UNITED STATES PATENT AND TRADEMARK OFFICE

APPLICATION NO.	FILING DATE	FIRST NAMED INVENTOR	ATTORNEY DOCKET NO.	CONFIRMATION NO.
10/605,852	10/30/2003	Martin Weiss	20073	2851
23470	7590	01/05/2006		
SRAM CORPORATION 1333 N. KINGSBURY, 4TH FLOOR CHICAGO, IL 60622			EXAMINER LUONG, VINH	
			ART UNIT 3682	PAPER NUMBER

Office Action Summary

Fig. 3

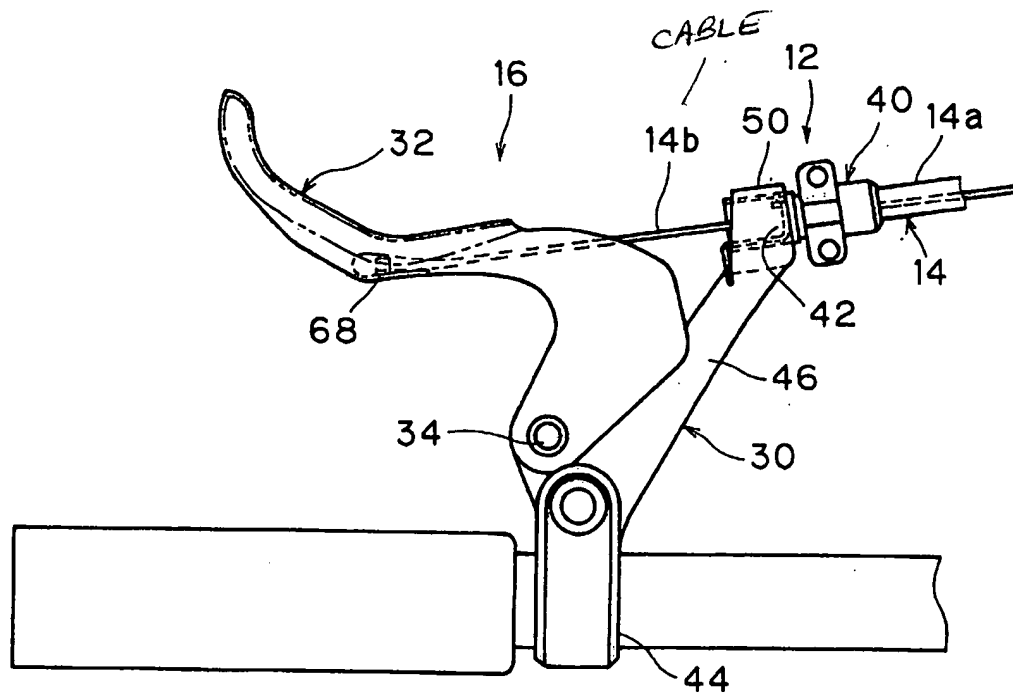
Regarding claim 16, the detent contour 80 has a non-round cross section (Fig. 5) and is configured such that the retention segment 93 has freedom to deflect, the retention segment 93 is configured to extend substantially parallel with a portion of the control cable 14b extending through the adjuster 40. See Fig. 3.

Fig. 4

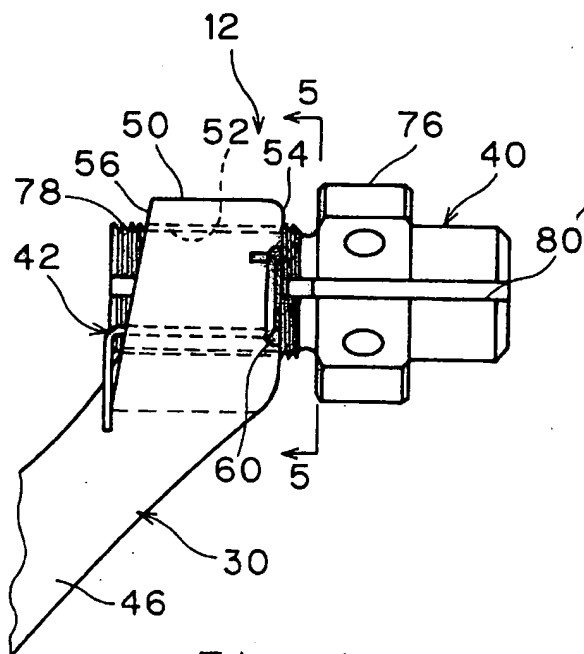
segment 94, the retention segment 93 of the spring element 42 engageable with the detent contour 80 and the support segment 94 of the spring element 42 supported by the housing 30. *Ibid.*, Figs. 4 and 5 and col. 5, line 56 through col. 6, line 64.

Fig. 5

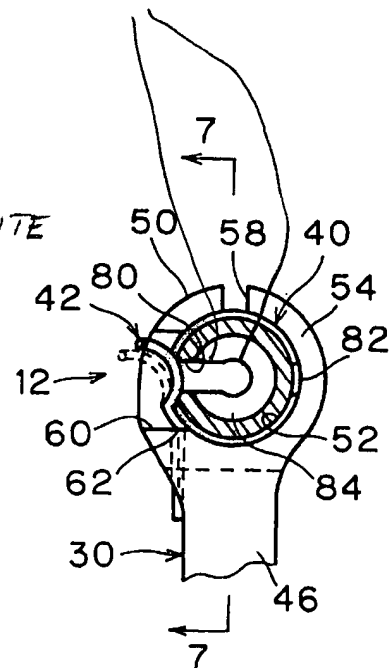
Regarding claim 17, the detent contour 80 includes varying surfaces (Fig. 5, see Attachment) configured to engage the retention segment 93 such that rotation of the adjuster 40 in a first direction requires a higher rotational force than rotation of the adjuster in a second direction. *Ibid.*, col. 6, lines 24-64.

Regarding claim 18, the detent contour 80 has flutes 80 (Att.) extending in an axial direction of the adjuster 40.
